American Aviation Corporation
318 Bishop Road Cleveland, Ohio 44143

Accessory Kit No. AK-102A
(Supersedes Accessory Kit No. AK-102)

TITLE: Winterization Kit

MODELS AFFECTED: AA1-0001 and up, AA1A-0001 and up

Figure 1. Winterization Kit Installation

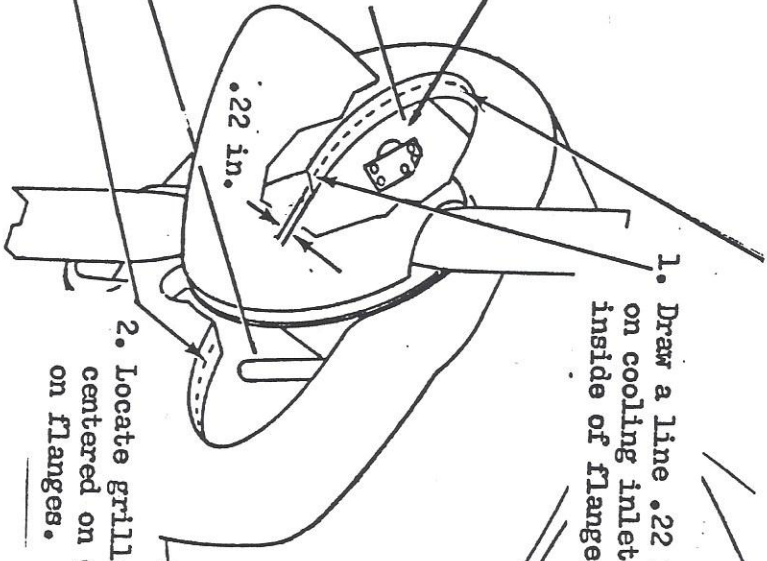
Changes: Added Serial Range AA1A-0001 and up. This kit also applicable to the Model AA-1A Trainer.

5. Drill out the 5 rivets (using #30 drill) holding the 502008-4 plate. Do not deform holes.

3. Remove grilles and drill 18 holes .139-.142 dia. in the locations marked.

1. Draw a line .22 in. from the rear edge of flange on cooling inlet. Extend line completely around inside of flange.

2. Locate grilles in the inlet with flange holes centered on drawn lines. Mark the hole locations on flanges.

7. Install the grilles with (18) AES1021Z-6-6 screws and A1181-6Z-1 nuts
